RE: PA 89-25 Hardee Power Station - Arcadia to Lee Substation Transmission Line
ROW Incompleteness Response.

HARDEE POWER STATION
PA 89-25
South Arcadia to Lee Incompleteness Response

DITCH "2D17/18" PLAN/PROFILE

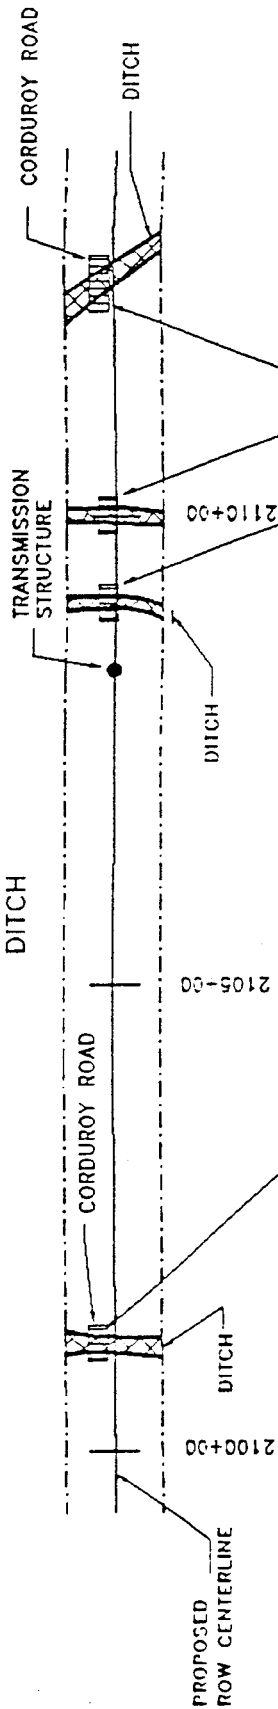
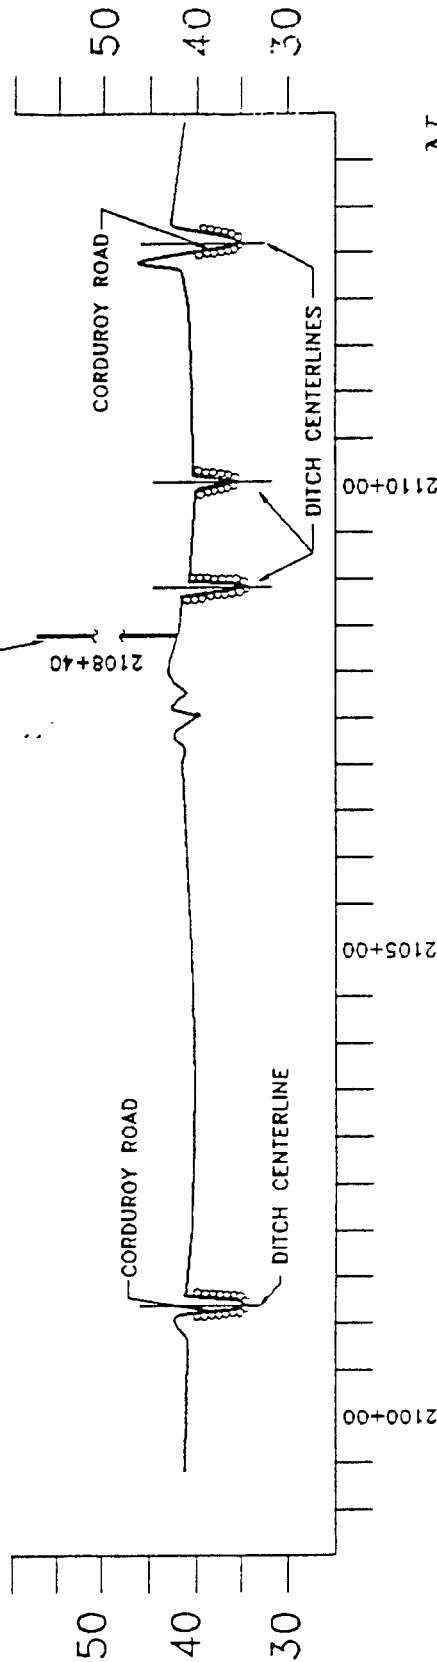
8. Figure 18/19 states that 0.08 ac. will be filled, while Table 2 states that 0.05 ac. will be filled. Please clarify which is correct.

The 0.05 ac. of corduroy road fill is correct. It is likely that we will be able to withdraw all of the fill for this area after our engineers review their needs for the area.

WETLAND "2C40"
PLAN/PROFILE

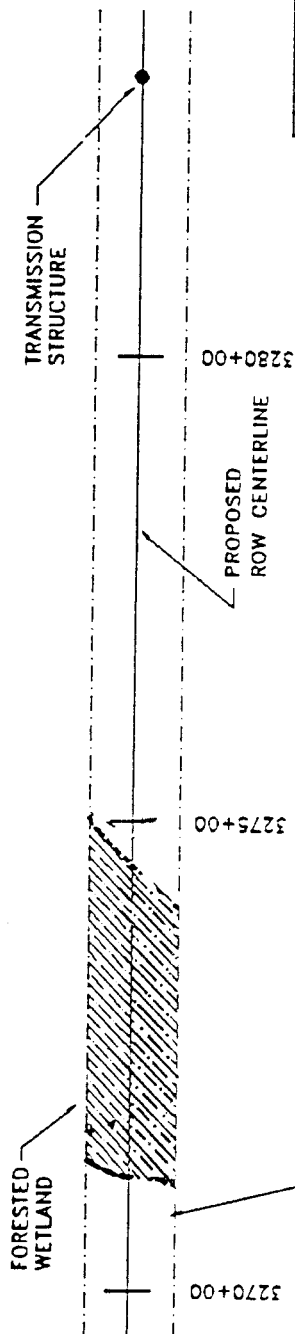
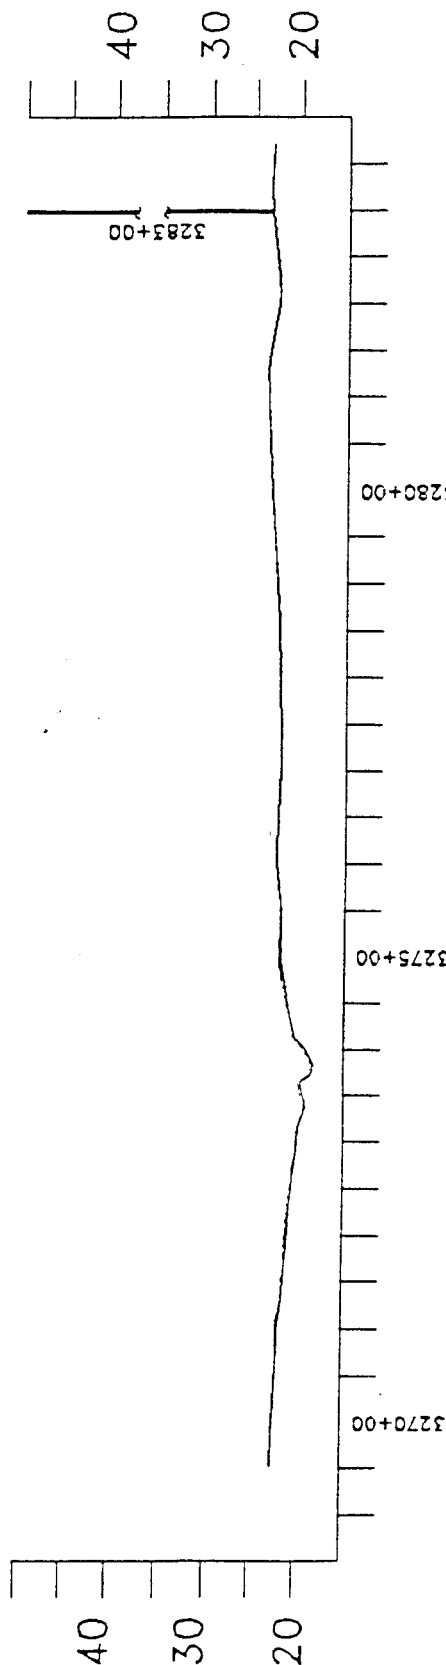
16. Figure 40 shows 0.48 ac. of forested clearing and 0.28 ac. of forested fill. Table 1 lists 0.48 ac. of forested fill and 0.28 ac. marsh fill for the same wetland. Please clarify which is correct.

Due to concerns over sizing of culverts and DNR easements, the culverts and power line structure will be removed from this wetland. This will result in no fill impacts, clearing impacts will increase to 0.76 ac.

WETLAND "2C32B" PLAN/PROFILE

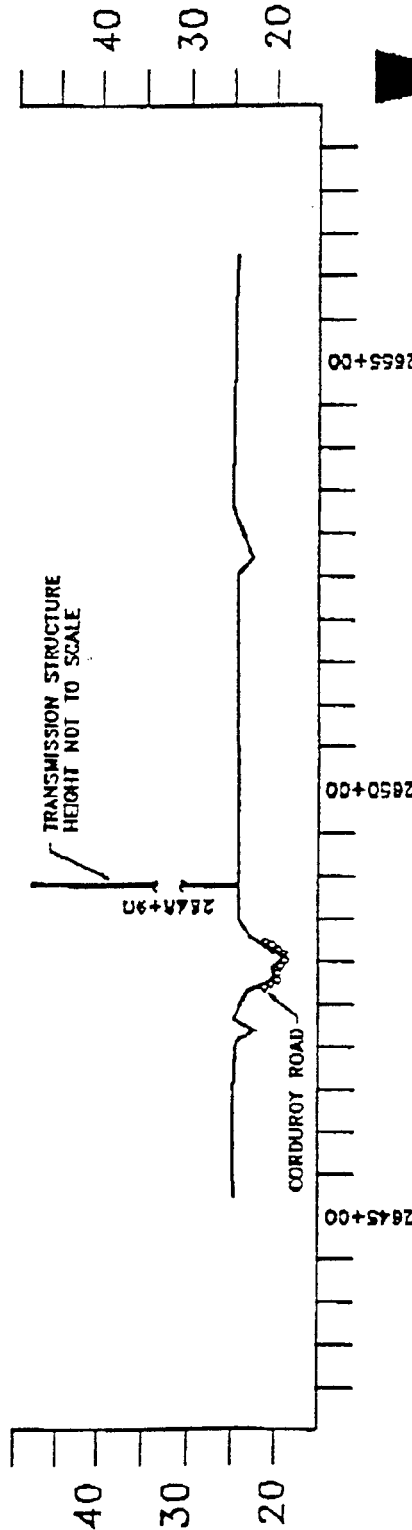
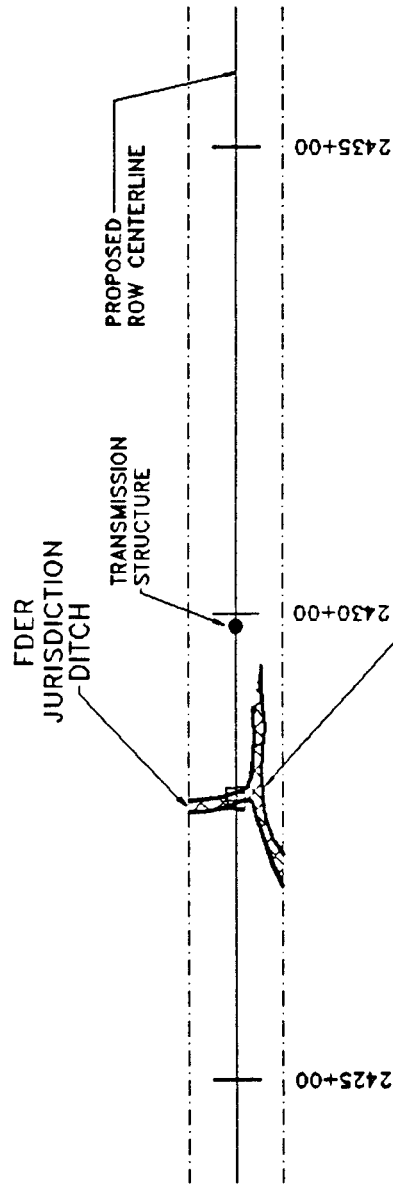
15. Figure 32 shows 0.13 ac. of shrub clearing not shown on Table 1.

The disturbed shrub areas will not be cleared outside of the corduroy road area. The 0.13 ac. of will not be cleared.

FIGURE 26A

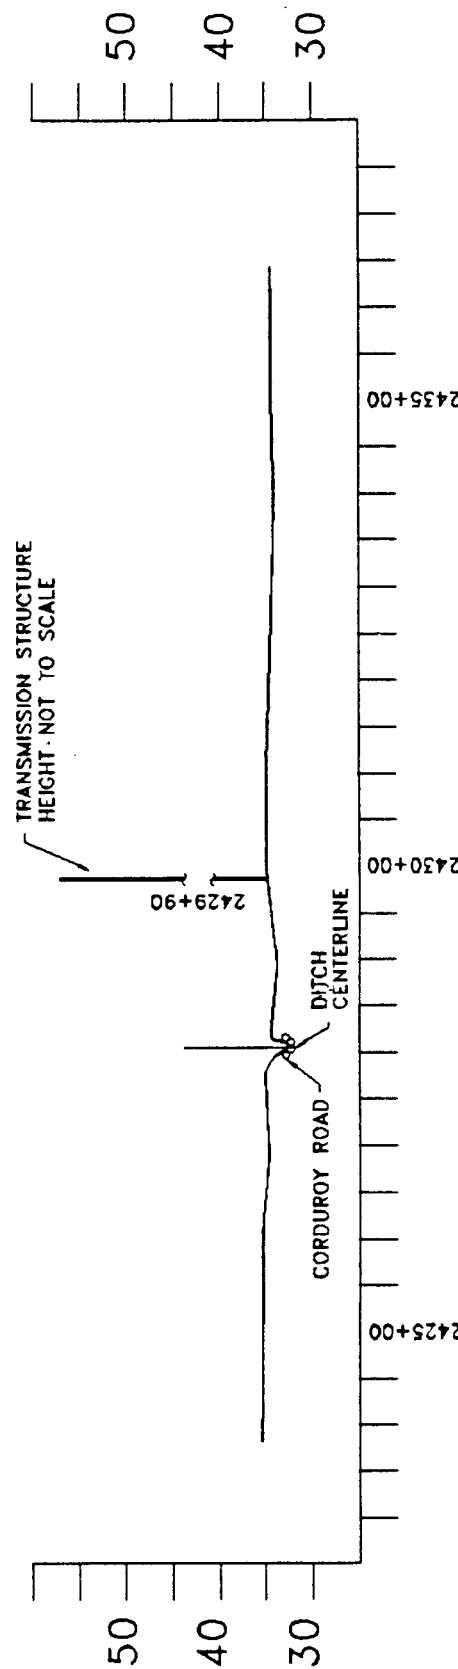
13. The drawing package contains two pages numbered as "Figure 26". Please renumber the package appropriately.

We have changed Figure 26, wetland 2C-27, to be 26 A.

PRAIRIE CREEK WETLAND "2D24" PLAN/PROFILE

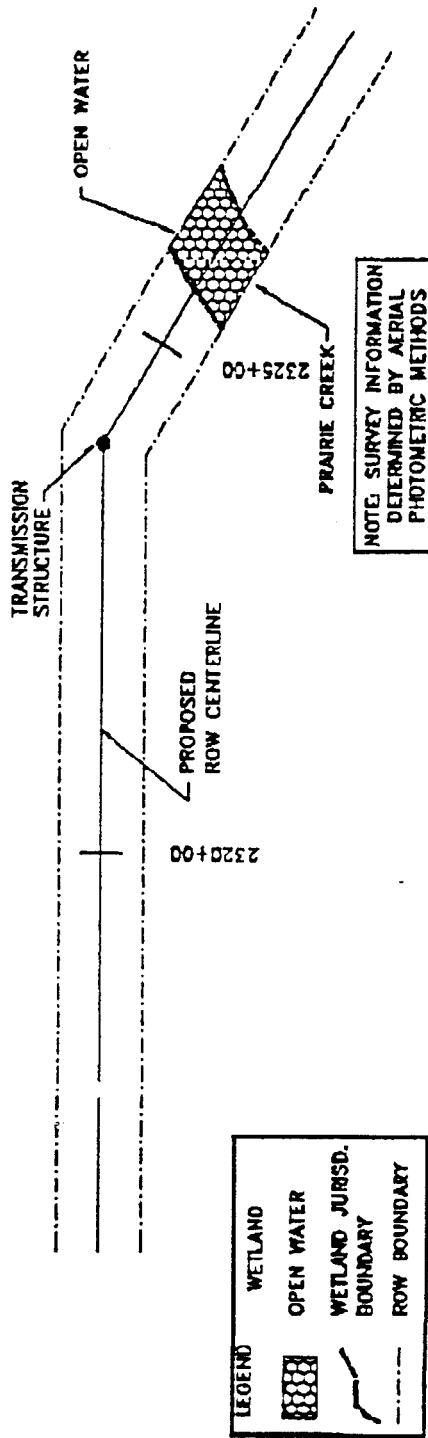
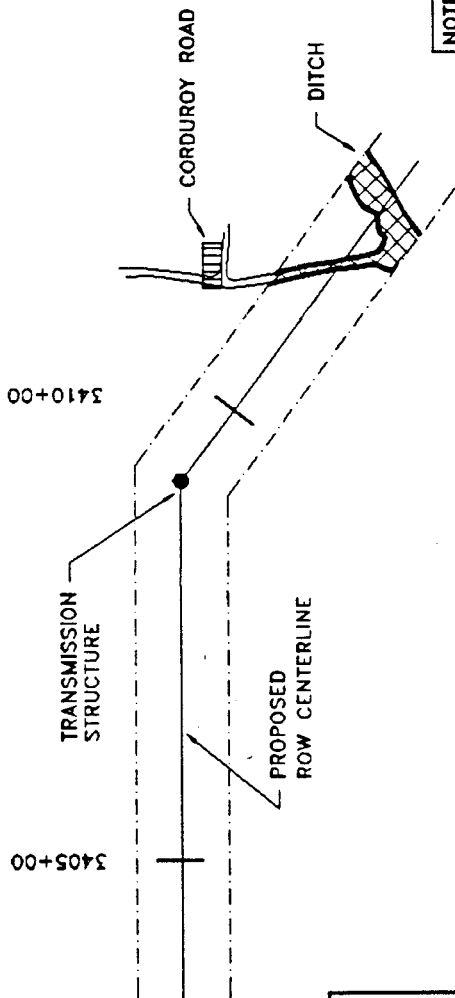
11. For Wetland 2D-24, figure 24 shows 0.24 ac. of wetland clearing, while Table 1 and the wetland description says there is no impact. Please clarify whether there is impact at this location or not.

The drawing indicates clearing in an open water area, this is obviously an error. There are no trees growing within the jurisdictional area of Prairie Creek within the ROW as the creek is steeply incised in this area. There will be no impact associated with the crossing of Prairie Creek.

DITCH "2C47" PLAN/PROFILE

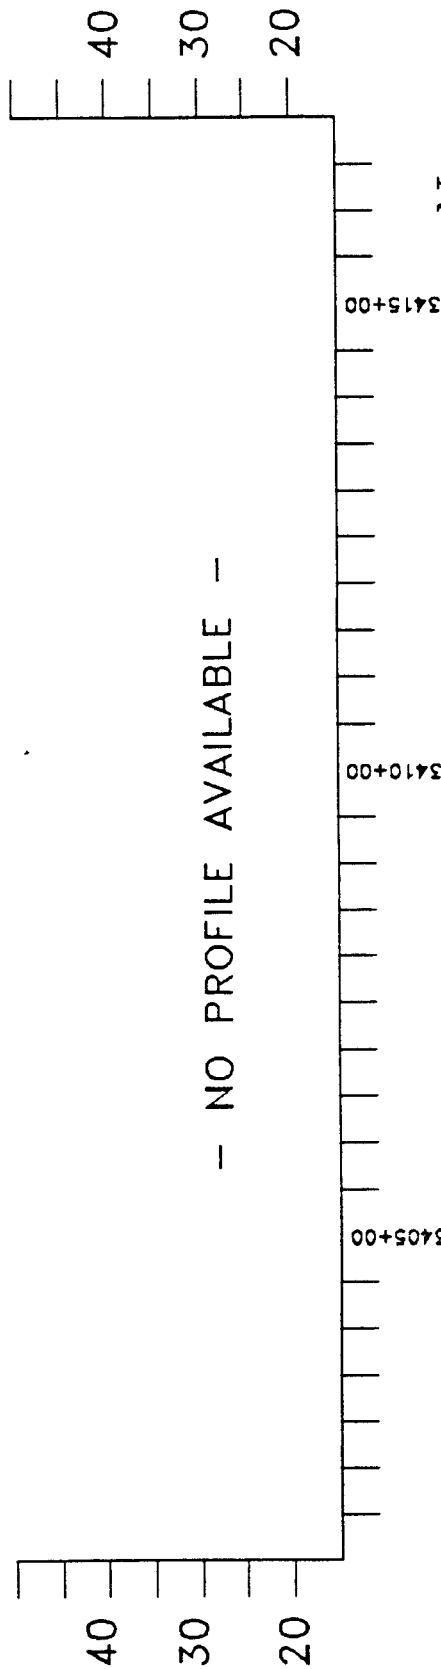
17. Figure 42 and 44 do not show the fill for the corduroy road.

The 0.01 acres of fill for the corduroy road in wetland 2C-47 (Figure 42) will be added to the drawing as it is shown on the Table. The ditch in Figure 44 was not present before December, 1991 and was not permitted by any agency. The ditch was dug by the county to limit access into the undeveloped area where our powerline is to be located. We do not feel we should have to mitigate for a corduroy road through a recent unpermitted upland cut ditch.

FIGURE 29/30

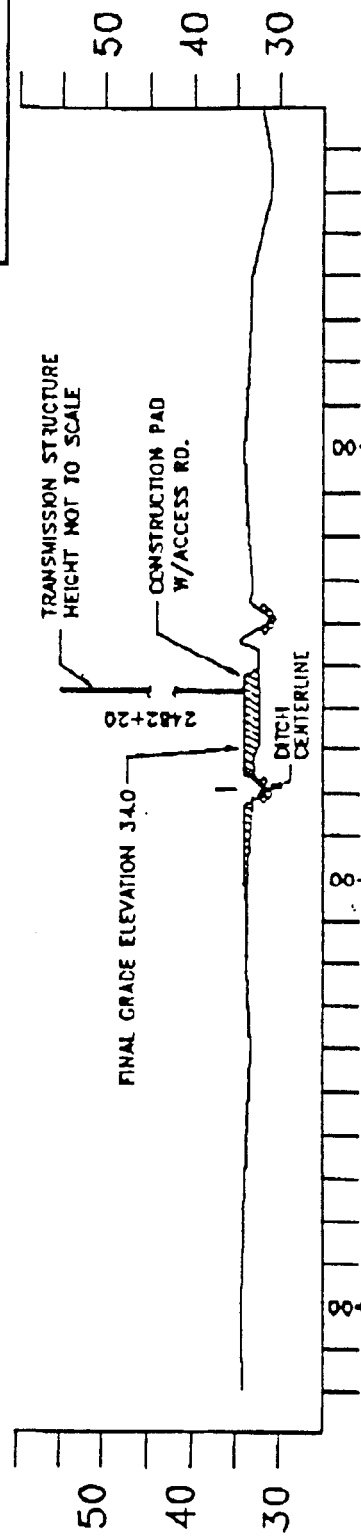
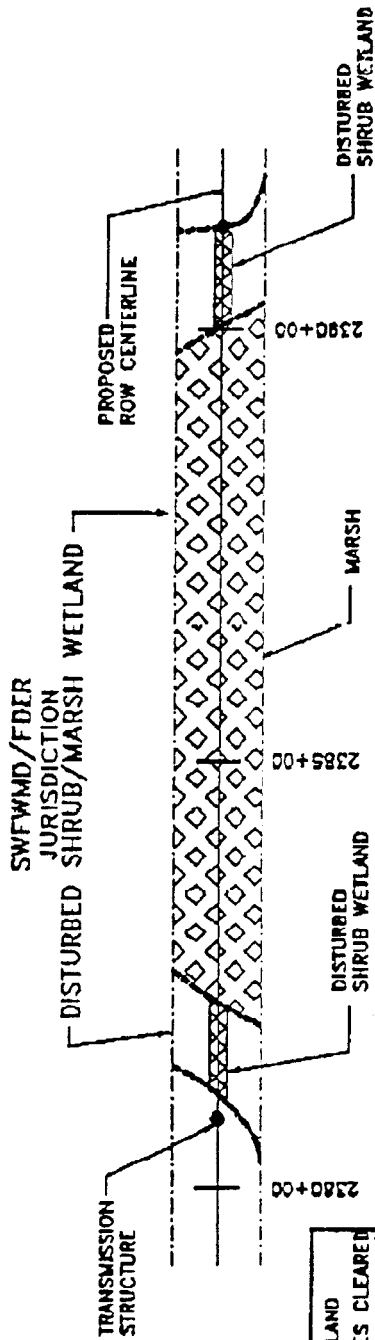
14. Both Figure 29/30 and 47 refer to "cleared marsh". Please clarify what is being described.

This was an error in drafting as no clearing will occur in these areas.

WETLAND "2C25" PLAN/PROFILE

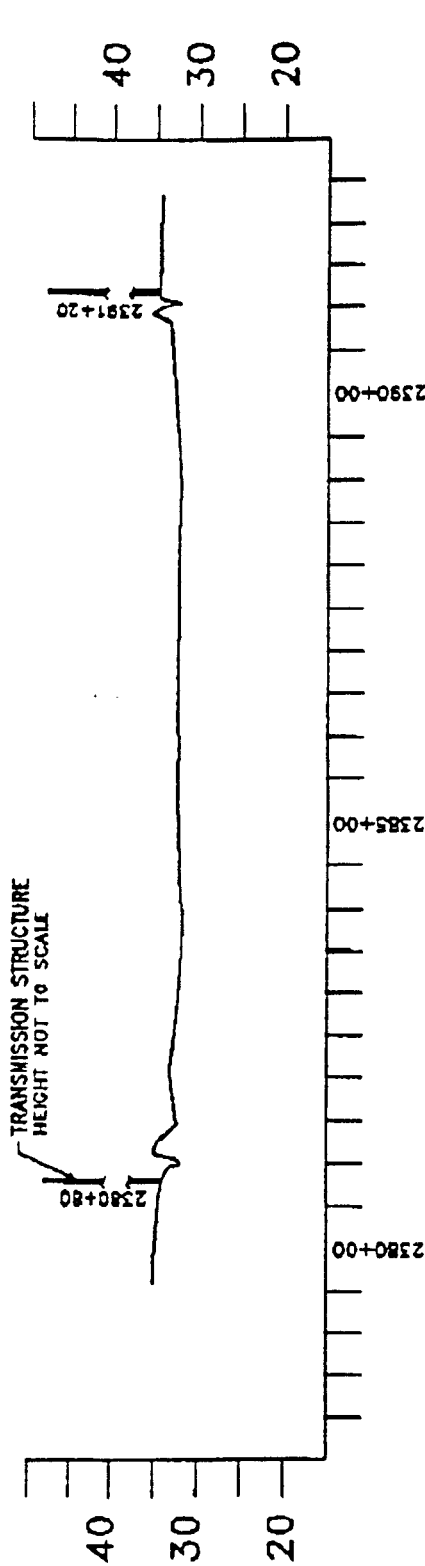
12. For Wetland 2C-25, Figure 26 says 0.10 ac. of shrub clearing and 1.8 ac. of marsh clearing. These impacts are not reflected in any other documents. Please correct this omission and clarify what "marsh clearing" is.

We do not need to clear marsh areas for the transmission line as this was an error in drafting. We will be clearing the 20 ft. wide path through
WET. RES. MGL

the shrubs and we will add this to the attached revised Table 1.
